MIL-D-23523D(SH)
AMENDMENT 1
5 April 1993

MILITARY SPECIFICATION SHEET

DEHYDRATOR, LOW PRESSURE AIR,
FOR SPECIAL APPLICATIONS

FIGURE 1

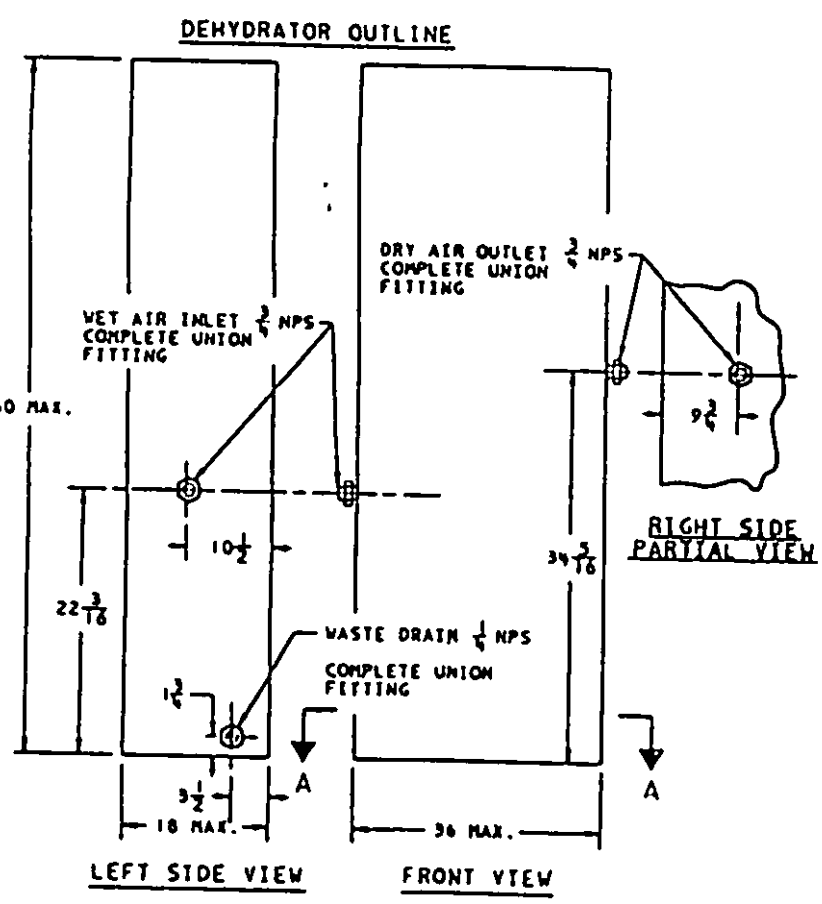
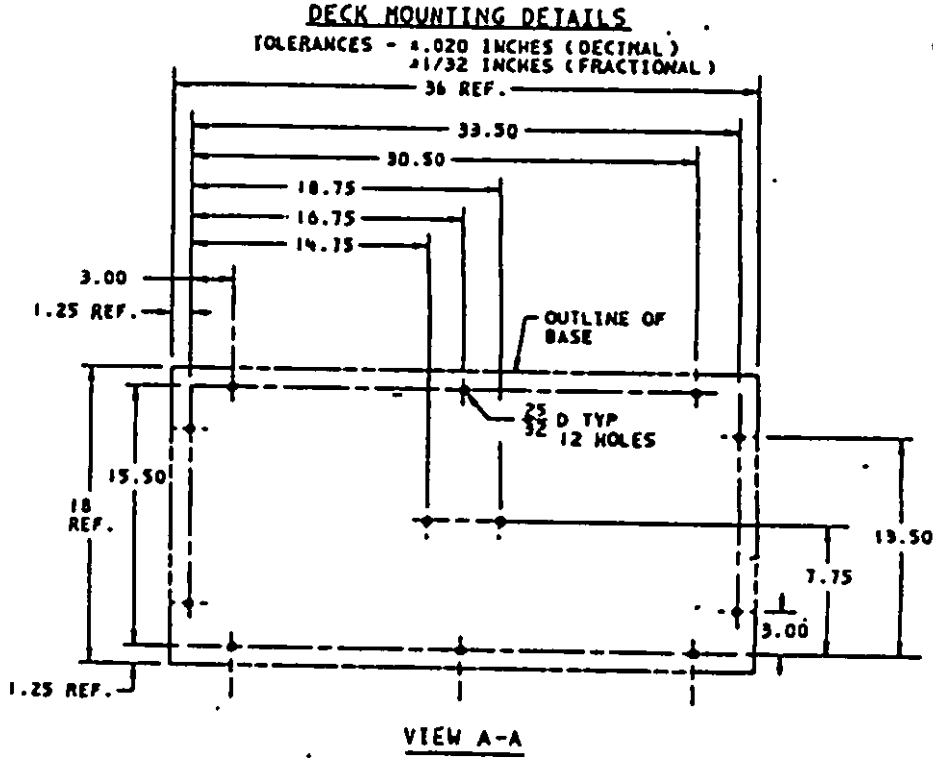
3.4 Delete second sentence and substitute, "Dehydrators shall be shipboard deck mounted and shall have mounting interface as detailed on figure 1."

3.8.2 Delete "piping and sizes" and substitute "piping, sizes and locations". Delete "as specified (6.2.1)" and substitute "as detailed in figure 1."

Add new page - FIGURE 1: - Insert the attached figure 1.
